**Subject: Site Investigation Work Plan Addendum**  
Cook Composites/Former Freeman Chemical/Arkema  
340 South Railroad Street, Saukville, Wisconsin  
BRRTS #: 02-46-000767

## **NEW, UPDATED CROSS SECTIONS AND FIGURES**

**SITE MAP**  
 COOK COMPOSITES AND POLYMERS  
 CORRECTIVE MEASURES STUDY  
 SAUKVILLE, WISCONSIN

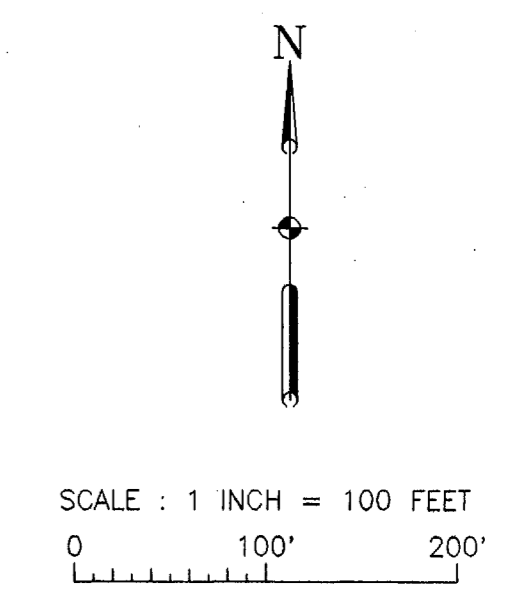
- Confirm material storage areas.

**Response:** *Raw materials and finished product were located in several specific locations historically at the Site. Per **Figure 4**, included in the SIWP, raw materials were stored in the tank farm, identified as location #10, while several areas were identified as barrel storage areas, identified as locations #1. The barrel storage areas were located in the southwest corner of the Site, to the north and northeast of Building #34, within Building #42 and to the south of AOC 1 along the east fence line.*

*The most recent facility layout, utilized from approximately 1996 through the idling of the Site at the end of 2015 identified raw material and finished product storage areas as follows:*

- *Current concrete-diked tank farm (raw materials);*
- *Interior storage tank rooms (raw materials and finished products) - Buildings # 10, 13, 16, 17, 47 and 55;*
- *Finished product warehouse (drums) – Buildings 32, 44 and 45; and,*

- Dry raw materials – Buildings #34, 42, 44 and 45.

A copy of the Site Map included in the 1996 CMS is attached in **Appendix A**.

1986 SITE CONDITIONS & CONSTRUCTION REPORT FIGURE 3-3

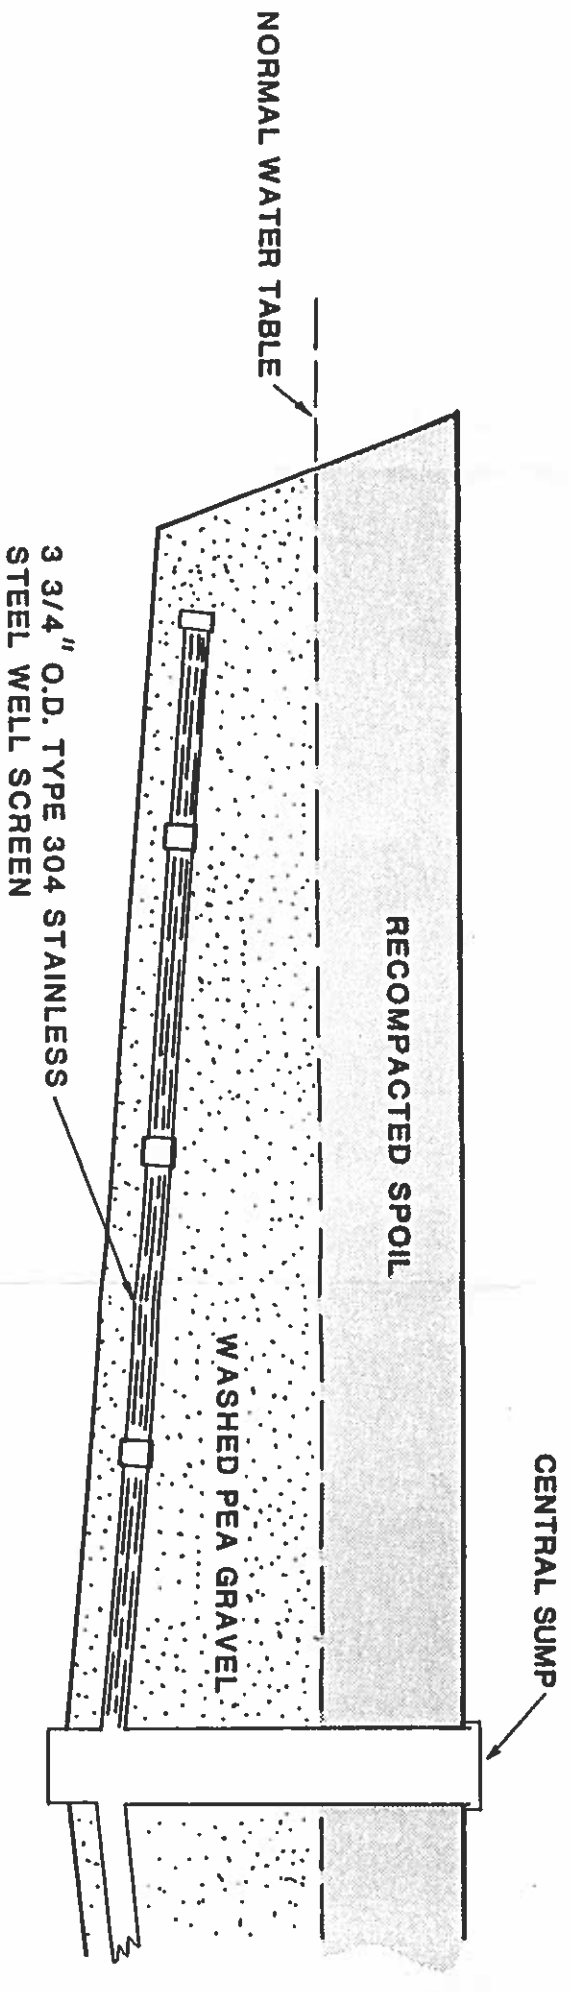
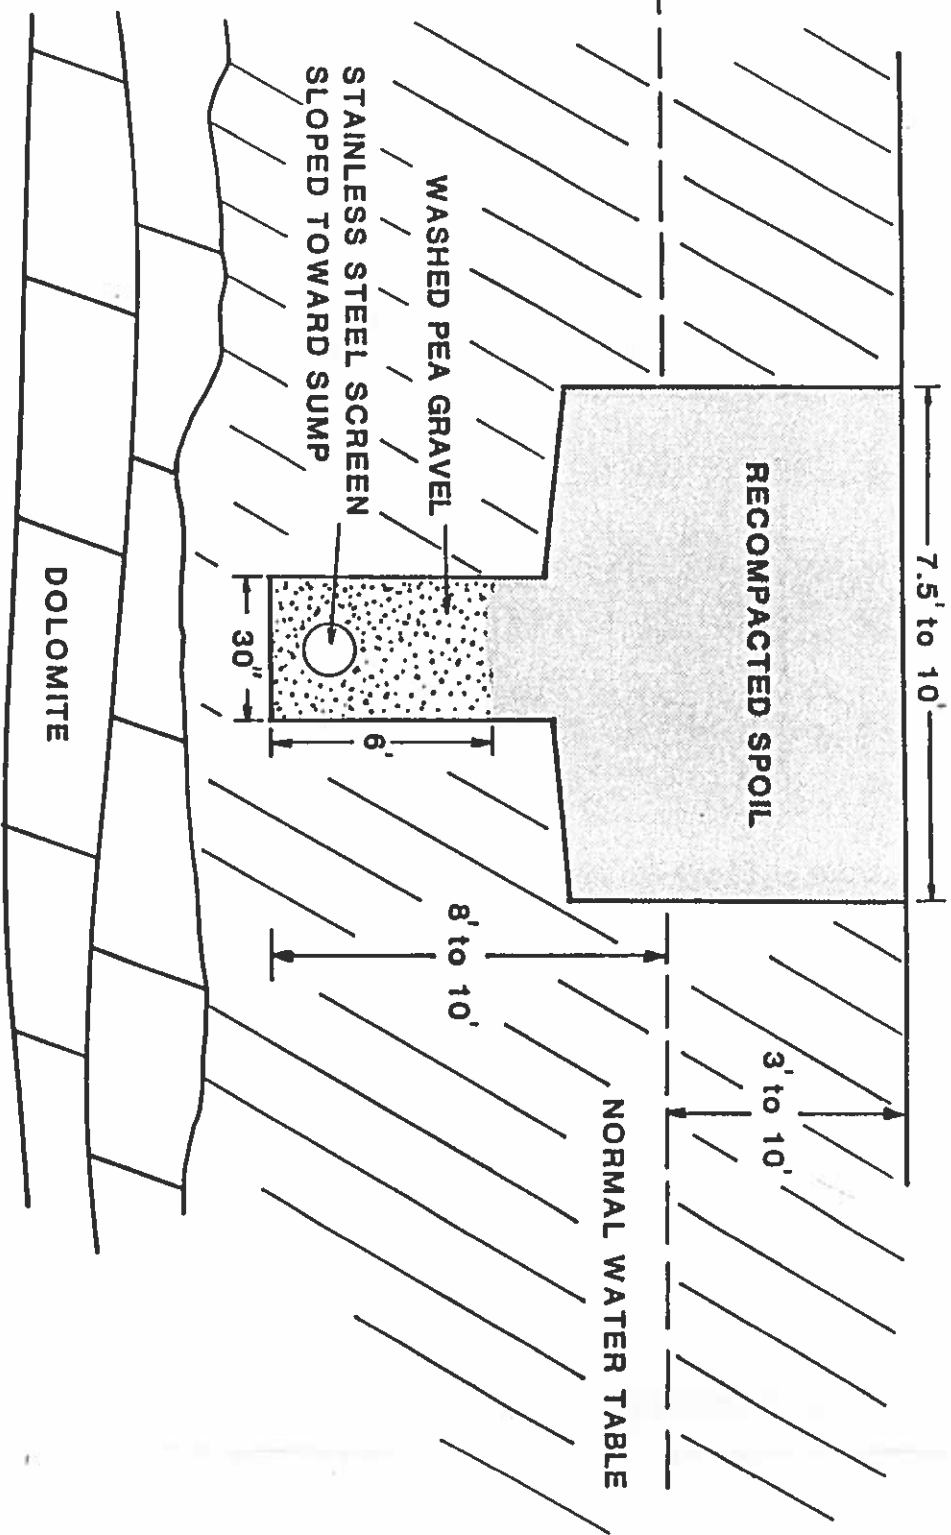
- Ranney Collectors
  - Justify that these sampling points are representative of shallow groundwater conditions.

**Response:** *Per information included in the Site Conditions & Construction Report prepared by Hatcher Incorporated in 1986, the Ranney Collectors designed for the Site consist of central large-diameter caissons to which lateral ditches drain groundwater via gravity. The laterals consist of a gravel-filled ditch containing a four-inch (4") diameter well screen radiating away from the bottom of each caisson at a designated gradient just above the upper surface of the underlying dolomite bedrock. A typical cross-section*

of the Ranney Collector system as presented on Figure 3-3 from the 1986 Site Conditions & Construction Report is attached for reference in **Appendix B**.

AOC 5 CDR FIGURE 2

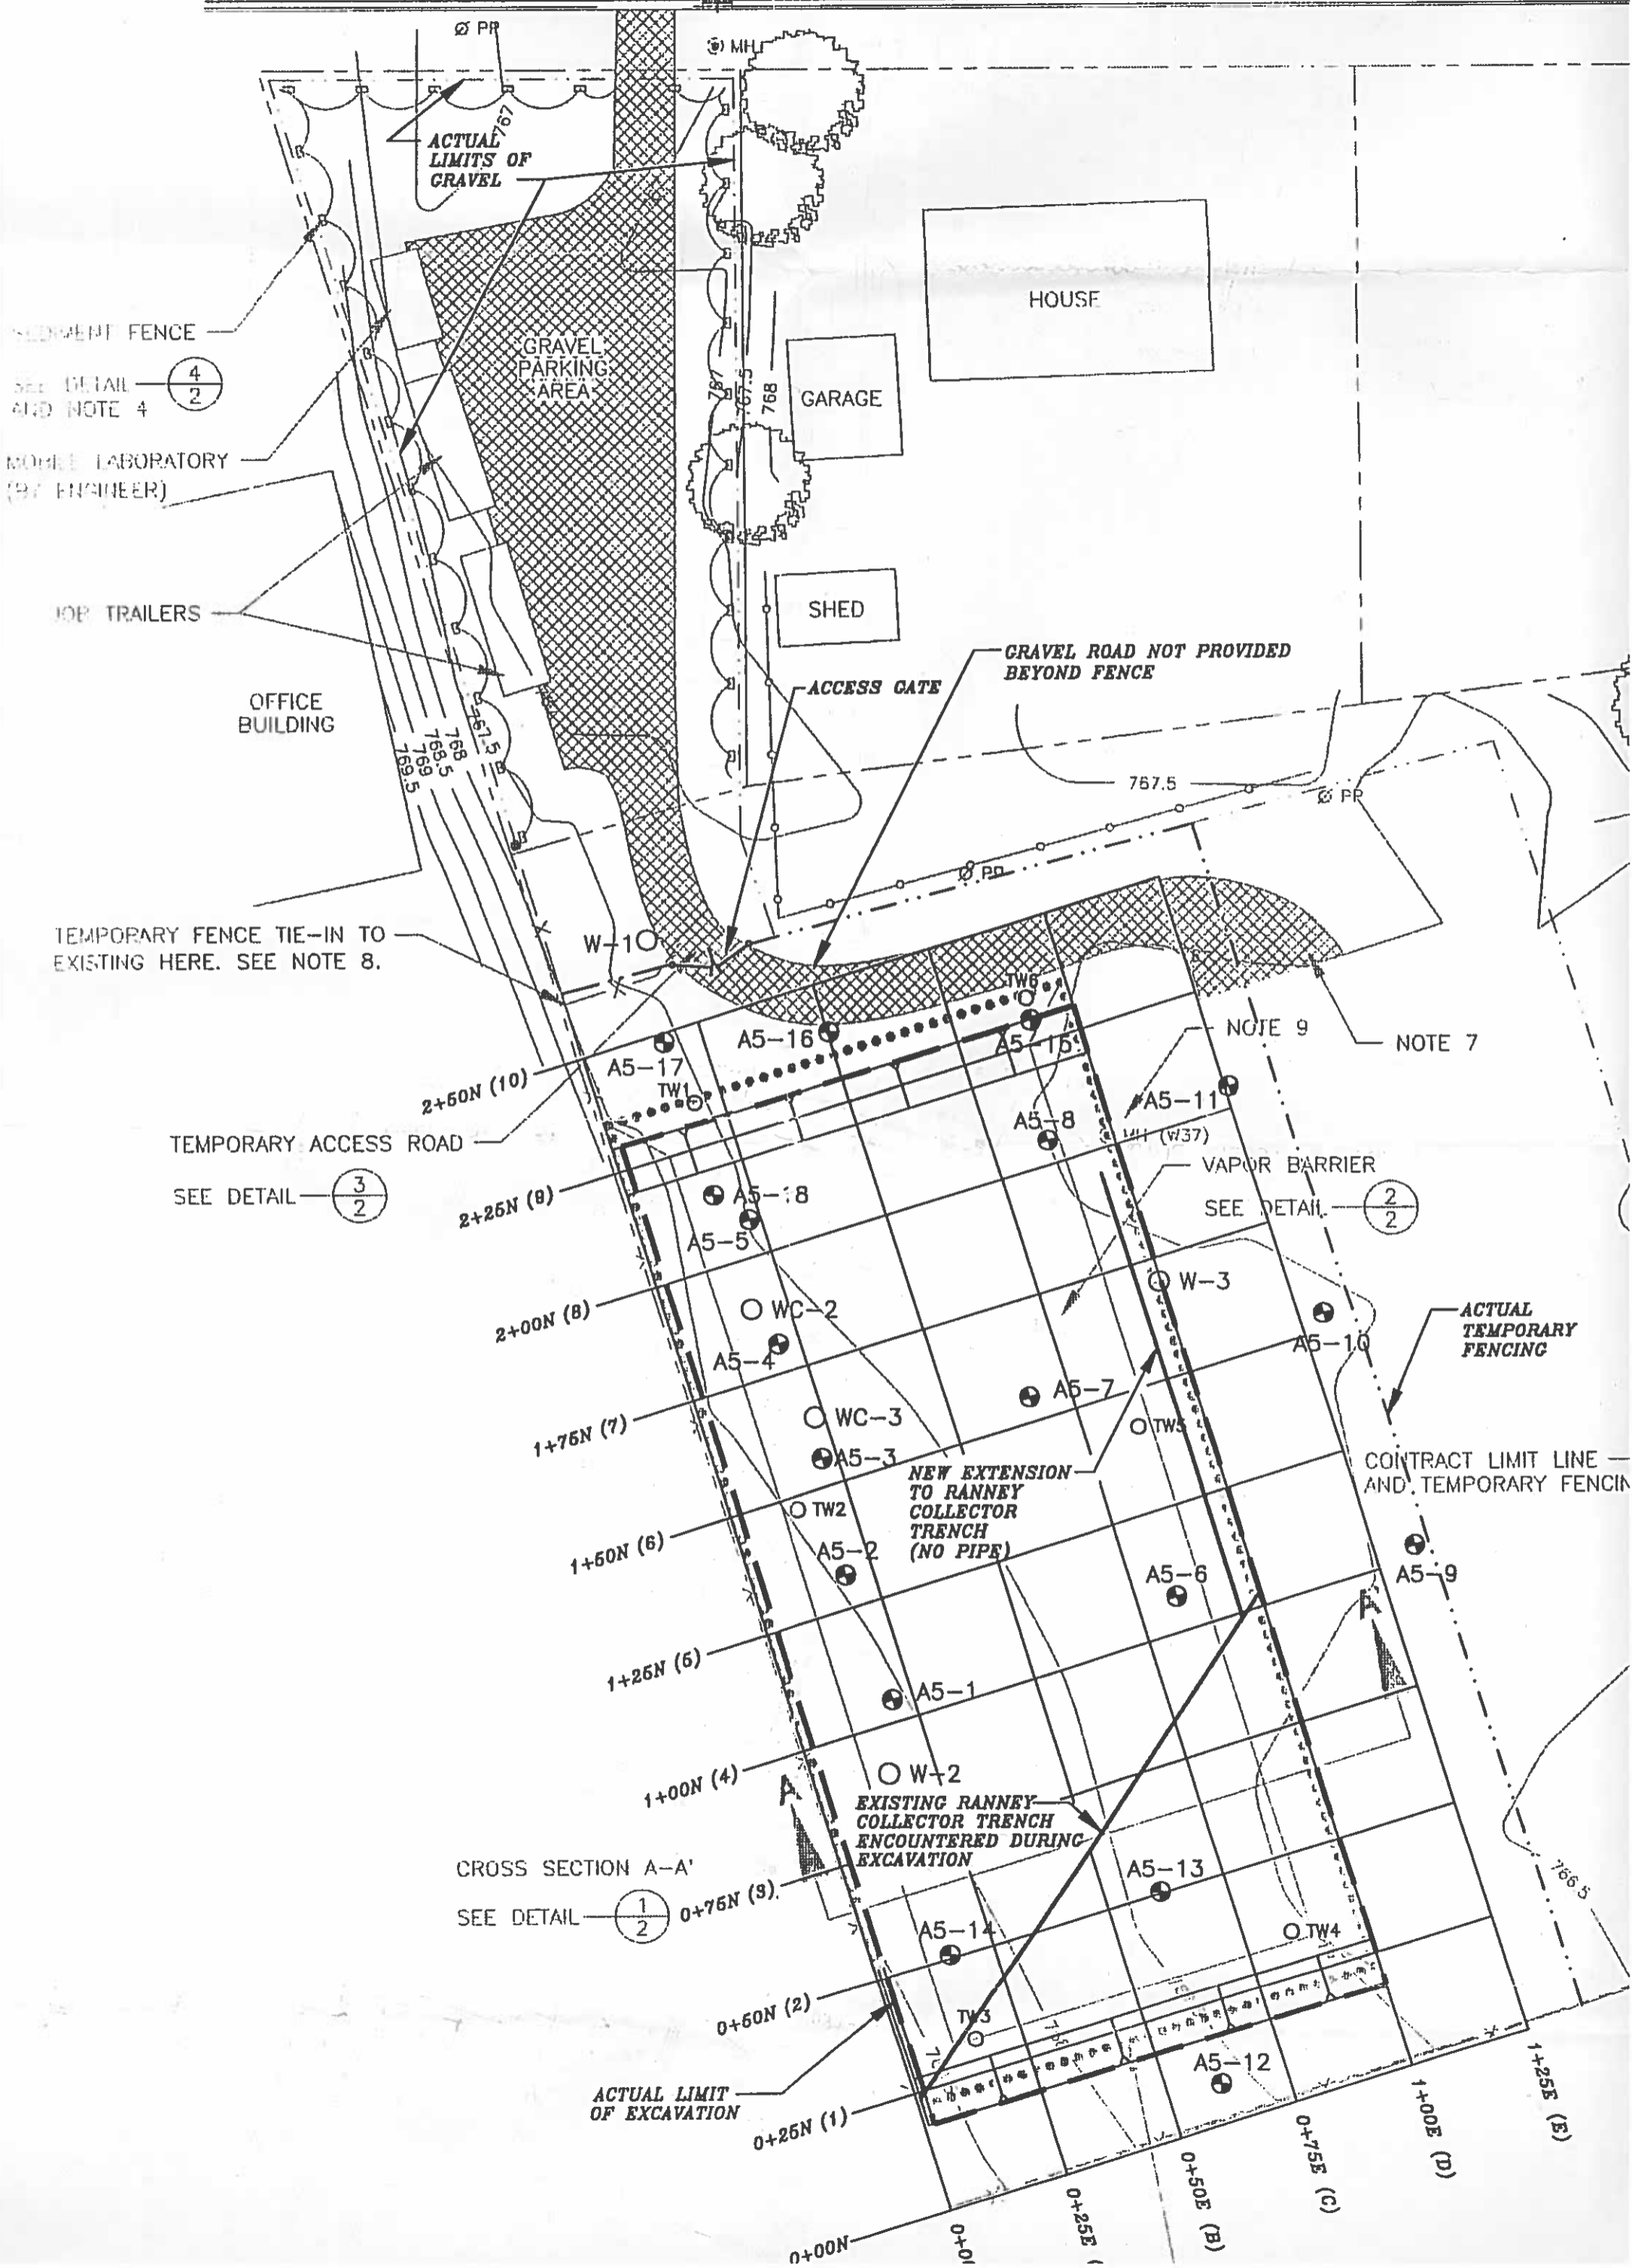
- Replacement well for W-37 is needed (It's the DNR's current understanding that a separate groundwater SIWP is to follow the additional soil investigations).

**Response:** W-37 was formerly located on the portion of the Church Ballfield (AOC 5) which was excavated and remediated in 1995/1996. W-37 was formerly located less than ten (10) ft from the end of the extension of one (1) of the legs of RC-3 (see Figure 2 from the AOC 5 CDR attached for your reference in **Appendix C**). Furthermore, a letter dated August 13, 1996 documents a telephone conversation between Mr. Eugene McLinn with RMT and Mr. Tim Mulholland with the WDNR regarding the verbal approval to abandon and eliminate W-37 from the monitoring network due to the extension of the RC-3 leg as discussed above. A copy of the letter is attached for your reference in **Appendix D**. Finally, as the remediation of AOC 5 included the installation of a geomembrane over the base of the remedial excavation, reinstallation of monitoring well W-37 would penetrate the geomembrane; thereby, negating the protective quality of the membrane. Finally, monitoring well W-16A is located approximately 160 feet to the southeast of the former W-37 location. As W-37 was completed to a maximum depth of 18 feet below the ground surface (ft bgs) and W-16A is completed to 16 ft bgs, the two (2) wells monitored the same aquifer. Based on groundwater elevation data, the W-16A location appears to be directly down-gradient from the former W-37 location. Based on this information, it is our opinion the replacement of monitoring wells W-37 is not necessary and would potentially cause additional contamination to occur due to penetrating the geomembrane placed in the AOC 5 remedial excavation.
